From: Maranche, Jason [Jason.Maranche@AlleghenyCounty.US]
Sent: 8/9/2021 7:05:17 PM
To: Leon-Guerrero, Tim [Leon-Guerrero.Tim@epa.gov]; Vozar, Shaun [Shaun.Vozar@AlleghenyCounty.US]
Subject: RE: Invenergy AEC Response to Comments
Attachments: NO2_monitor_report_2019.pdf

From: Leon-Guerrero, Tim <Leon-Guerrero.Tim@epa.gov>
Sent: Wednesday, August 4, 2021 7:07 AM
To: Vozar, Shaun <Shaun.Vozar@AlleghenyCounty.US>
Cc: Maranche, Jason <Jason.Maranche@AlleghenyCounty.US>
Subject: Invenergy AEC Response to Comments

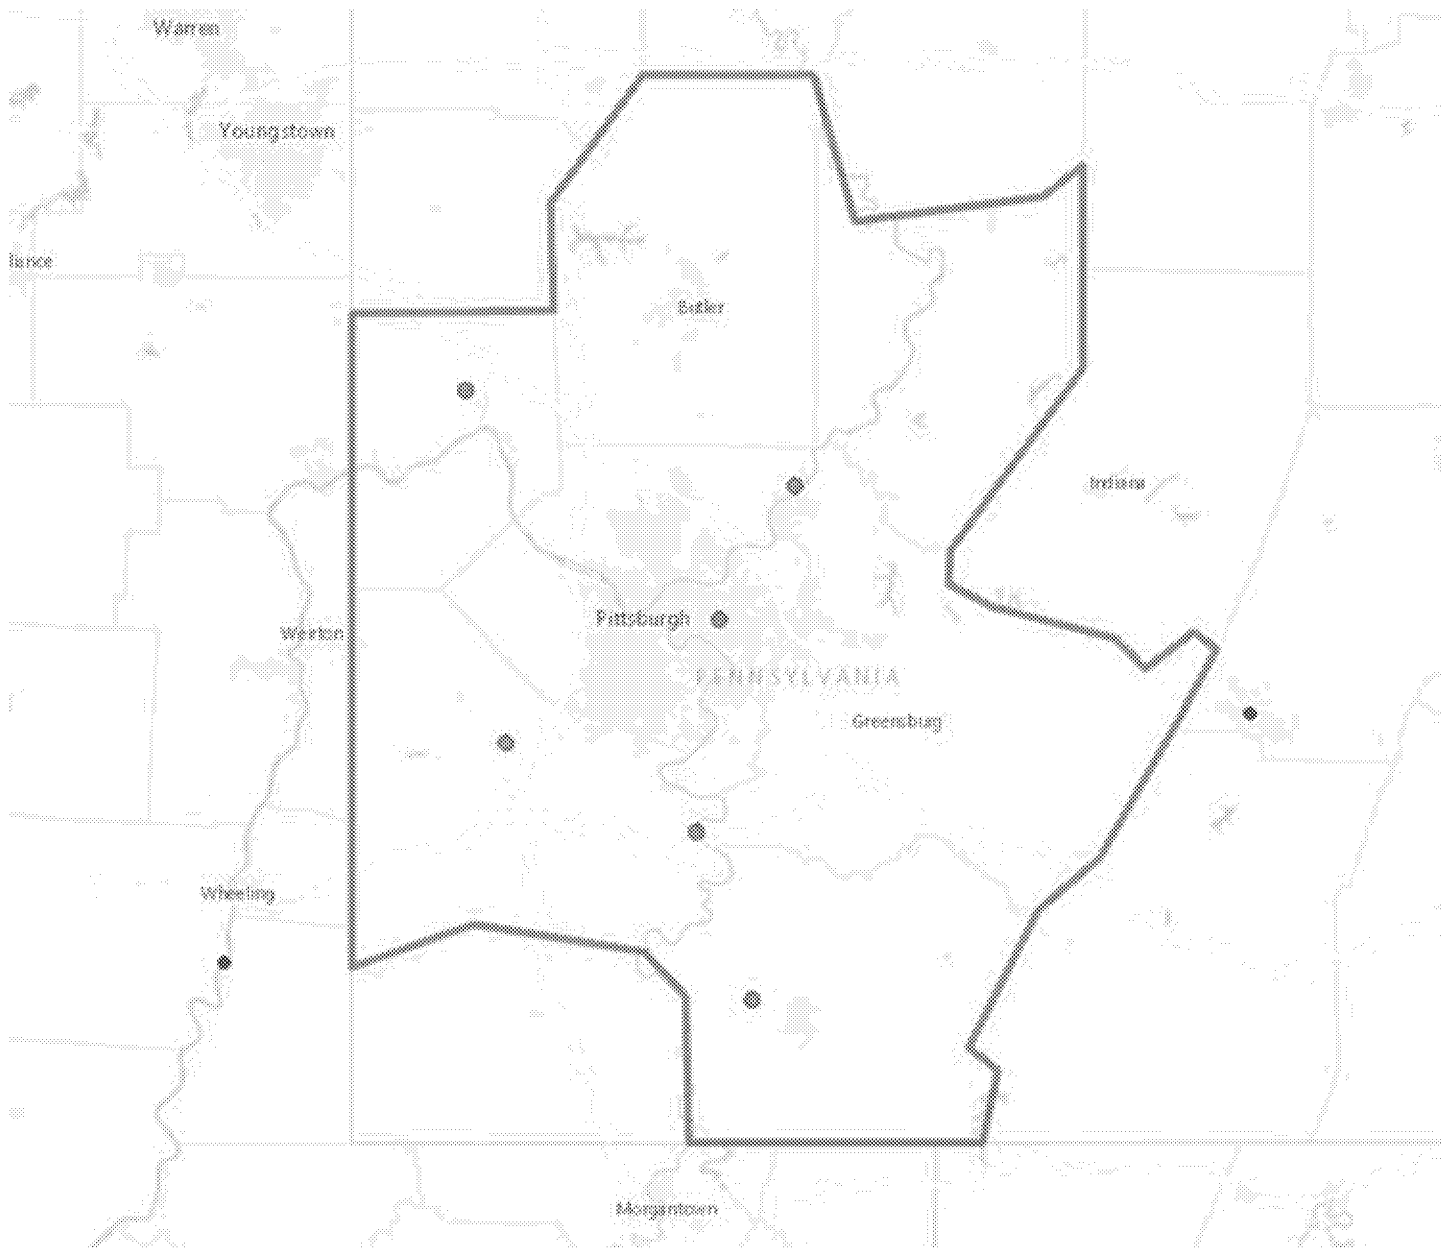
Attached is a the summary report from AirData for the NO2 monitors in the CBSA for year 2019. (Also, a map of the area and monitors from the EPA NetAssess app is copied below (as used in our 2020 network assessment.) I wanted to make sure to exclude any data from 2020 because of potential low bias during COVID (although the numbers for 2020 are actually similar to 2019).

The most appropriate background site for the area at this point is probably the Houston/Marcellus site (220 Meddings Rd) in Washington Co. The Uniontown site (New Salem Rd) in Fayette Co is the lowest overall for SW PA. Both of these sites are relatively newer sites...I think only Houston would have more than three years of data.
